TECHNICAL SERVICE BULLETIN

| Classification: BT23-013 | Reference: NTB23-069 | Date: August 30, 2023 |

FRONT PASSENGER INSTRUMENT LOWER COVER FITMENT

APPLIED VEHICLES: 2023 ARIYA (FE0)
APPLIED DATES: Built on or before June 13, 2023

Figure 3

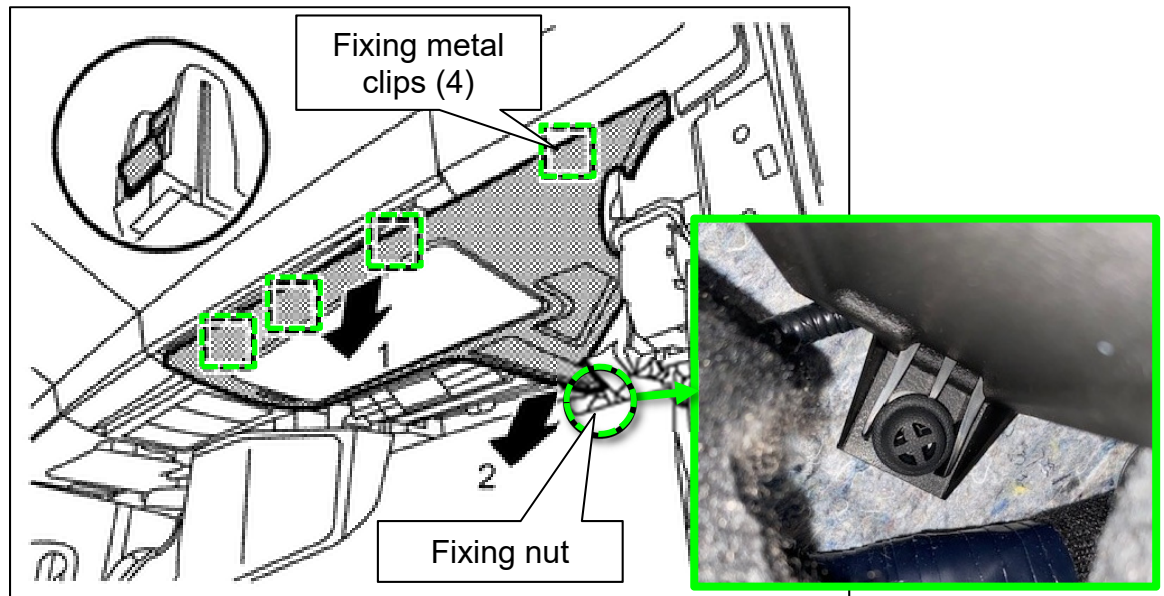
1. Remove the front passenger instrument lower cover.
 - a. Remove the instrument lower cover fixing nut.
 - b. Disengage the four (4) fixing metal clips according to numerical order 1→2 indicated by the arrows as shown in Figure 3, and then remove the instrument lower cover.

Figure 4

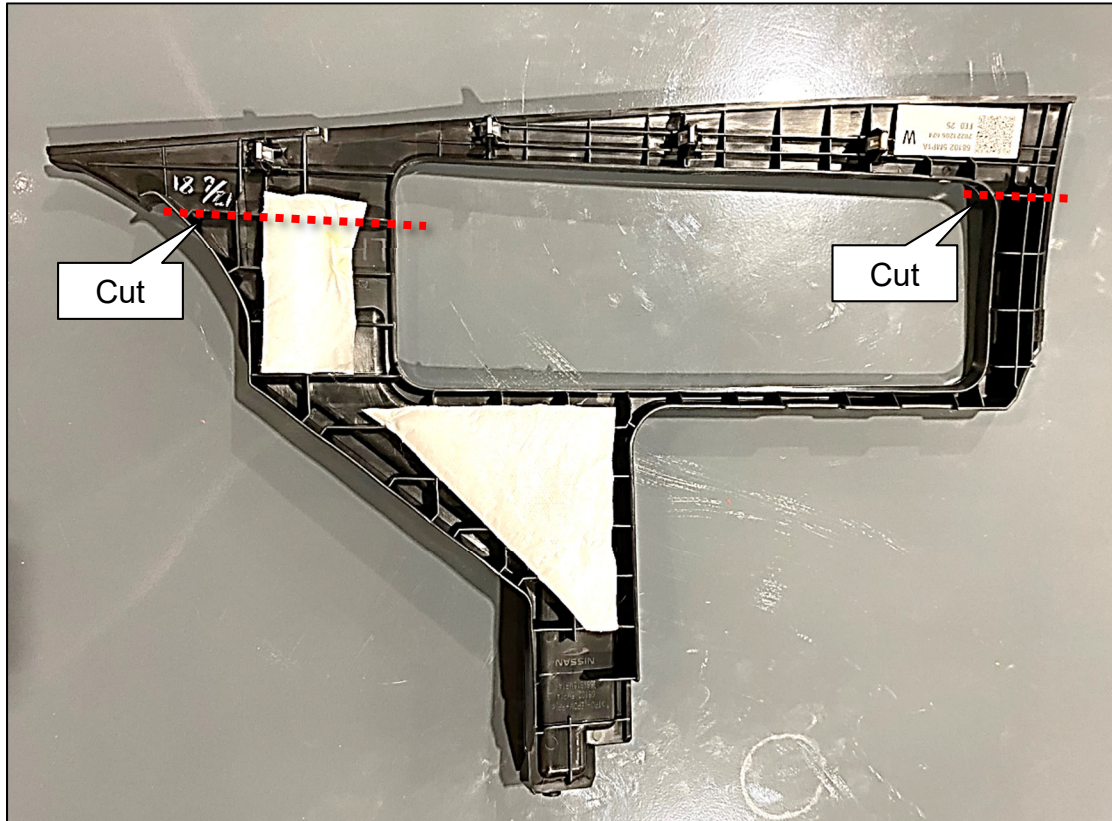
- Using a suitable cutting tool, cut along the ribs shown in Figure 4.

- Using a suitable trimming or grinding tool, remove all the sharp edges around the cut portions.
